CIRCULATE TO:-				
SERVICE MGR.	X			
RECEPTION	X			
WORKSHOP	X			
PARTS	X	SUBJECT		04/10/95
		<b>Vehicle Battery Discharge (Diesel Only)</b>		NRR/86/14/95/EN
MODEL		AFFECTED VEHICLES		
New Range Rover B.M.W Diesel Derivatives		LP Upto 323415		
		LH		
		LJ		
		LD

<b>Page 2 of 2</b>	SUBJECT <b>Vehicle Battery Discharge (Diesel Only)</b>	04/10/95 NRR/86/14/95/EN
MODEL <b>New Range Rover B.M.W Diesel Derivatives</b>	AFFECTED VEHICLES <b>LP Upto 323415</b> <b>LH</b> <b>LJ</b> <b>LD</b>

<p>ILLUSTRATION</p> 
--

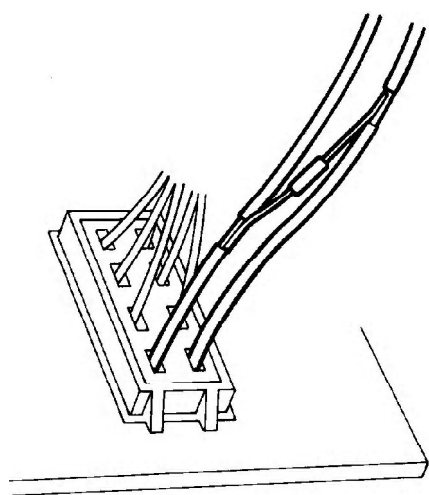
<p>DETAIL</p> <p>Reports have been received which indicate a rapid discharge of the vehicle battery on New Range Rover Diesel derivatives, over a 2 to 3 day period.</p> <p>Investigations have shown the cause to be the BeCM failing to enter sleep mode (partial shutdown).</p>
<p>ACTION REQUIRED</p> <p>Upon customer complaint of the vehicle battery discharging rapidly, without obvious reason, follow the procedure detailed below.</p>

<p>PROCEDURE</p> <ol style="list-style-type: none"> <li>1. Remove front passenger side footwell closing panel and remove the diagnostic plug from the panel.</li> <li>2. Remove the tape from around the diagnostic harness wires.</li> <li>3. Remove approximately 10mm of insulation from the brown wire (N) pin 16 in the diagnostic connector (see illustration opposite).</li> <li>4. <b>NOTE: Do not cut through the copper wire.</b></li> <li>5. Remove approximately 10mm of insulation from the pink/red wire(KR) pin 7, stagger the gaps in the insulation as per the illustration.</li> </ol> <p>Continued.....</p>
--

6. Crimp one end of resistor onto each wire (see illustration).
7. Solder each of the crimps, as crimping alone is not sufficient to guarantee a reliable fix.
8. Tape full length of resistor with insulation tape to ensure that the wire provides the mechanical support for the resistor.
9. Ensure the BeCM goes to sleep after carrying out this modification, this can be achieved by the following procedure.
10. Ensure the drivers door is closed and the interior lights are switched off, switch on the ignition, switch off the ignition.
11. Open the drivers door and leave open, switch off the interior lights.
12. The message 'Ignition key in' should then be displayed on the instrument pack for 2 minutes.
13. After 2 minutes the message should clear, this will indicate the BeCM is asleep.
14. Refit connector and closing panel
